**PLANNING COMMISSION AGENDA
THURSDAY, FEBRUARY 14, 2019
7:00 PM**

Subject: **Panda Express – Amend Planned Development and Site Plan Application #19-002–Request to construct an approximate 2,300 square foot Panda Express Restaurant, with one drive-through window, within the Hartland Towne Square development (Outlot #8)** Project site is located north of Highland Road (M-59), south of Hartland Square Drive, and west of Hartland Road (Tax Parcel ID #4708-21-400-074)

A-200

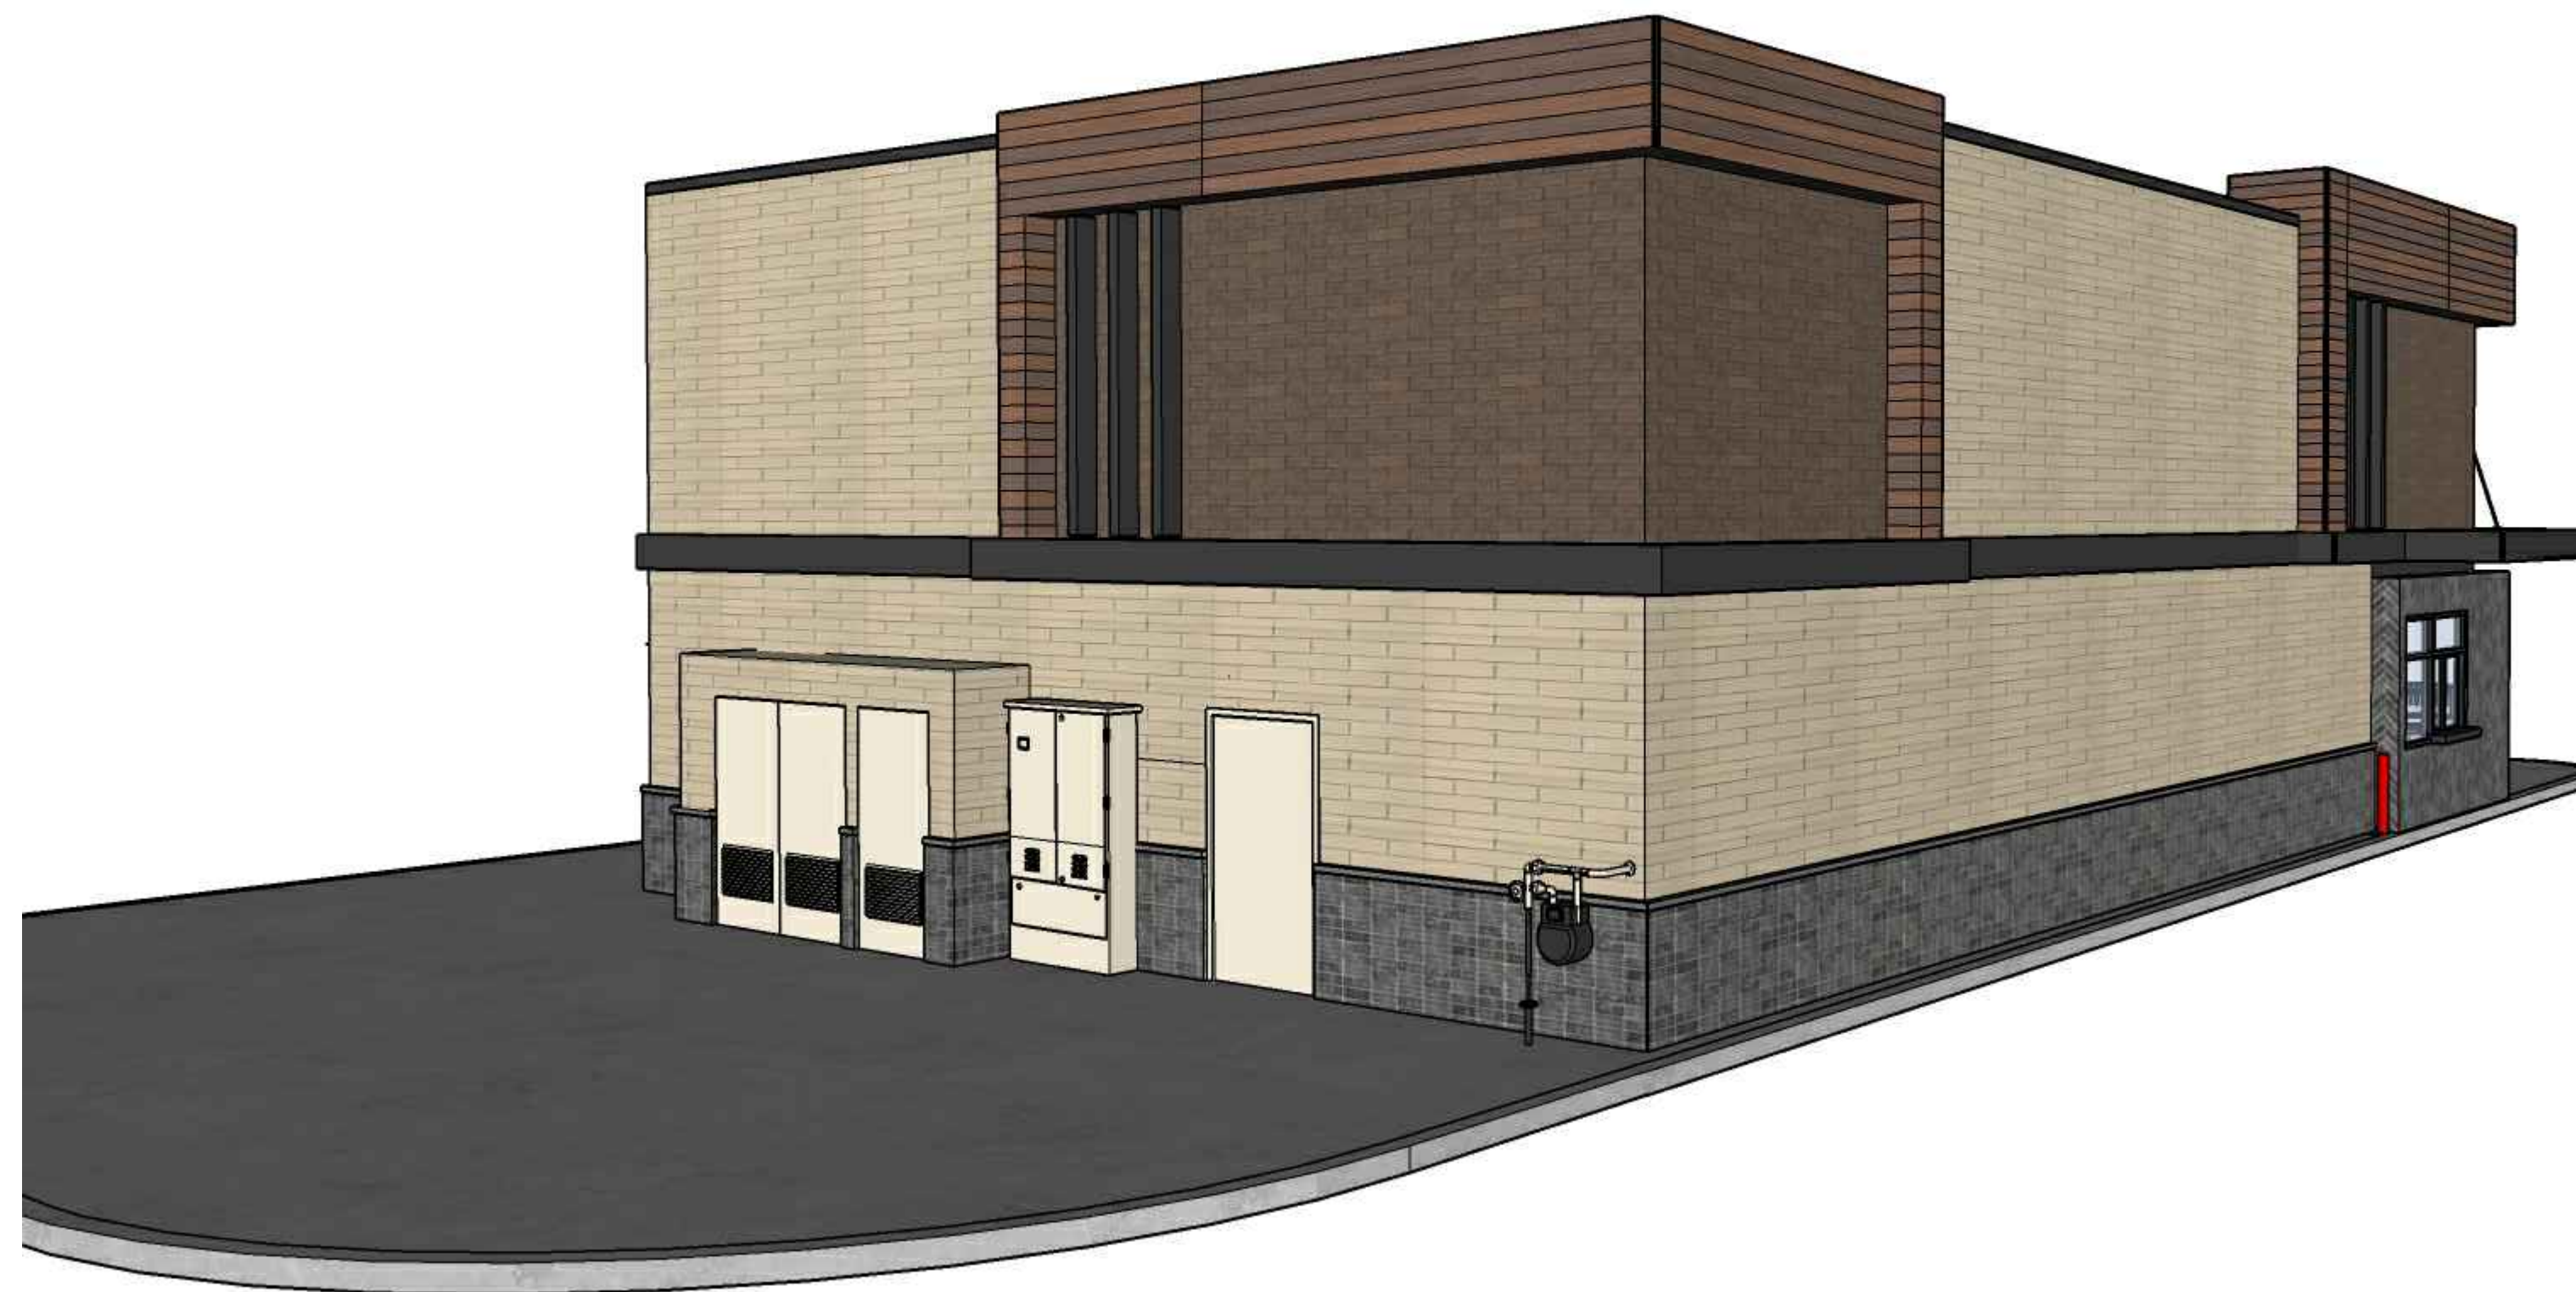
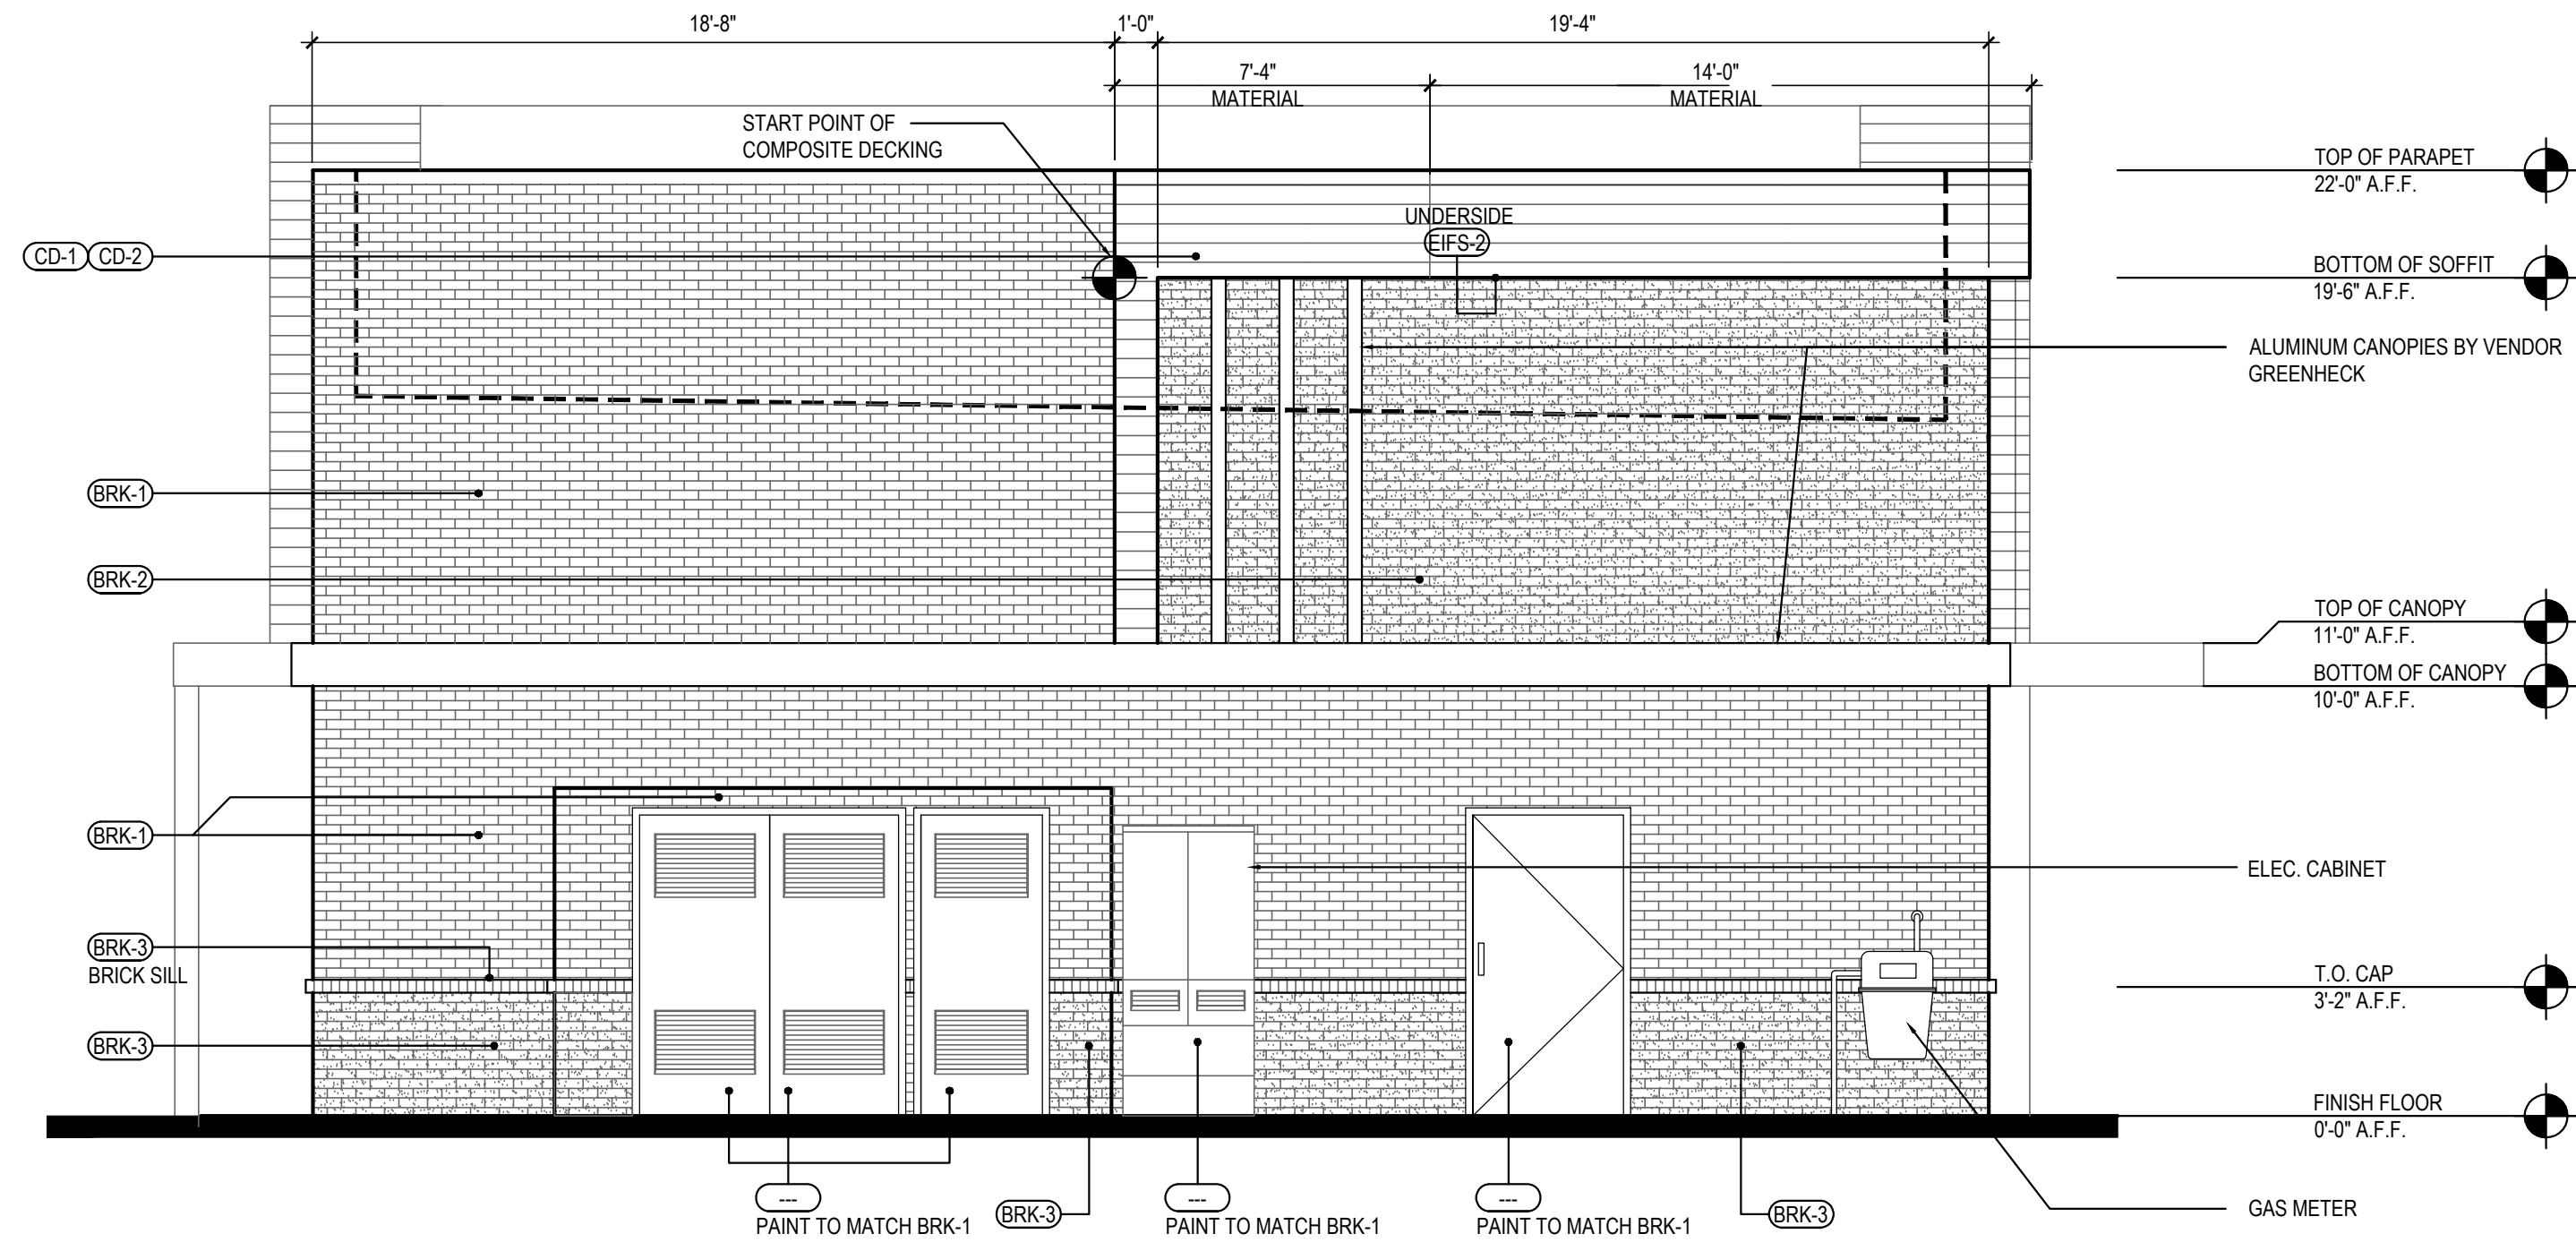
- Roof appurtenances – All rooftop equipment is to be screened behind the proposed parapet walls, per Sheet A-200 and A-201(revised elevations, PDF version only).
- Transformer (north side of building) – screening of a transformer is required. The plan shows two ornamental trees on the north side of the transformer which provides some screening. Screening of the east and north sides of the transformer with landscaping is difficult due to spatial constraints and bike racks (east of transformer).
- Bike Racks – Bike racks are provided north and east of the building and adjacent to parking.
- Ground Sign – A monument sign is not shown on the plans. The Pattern Book provides design standards for a monument sign regarding size, height and type of building
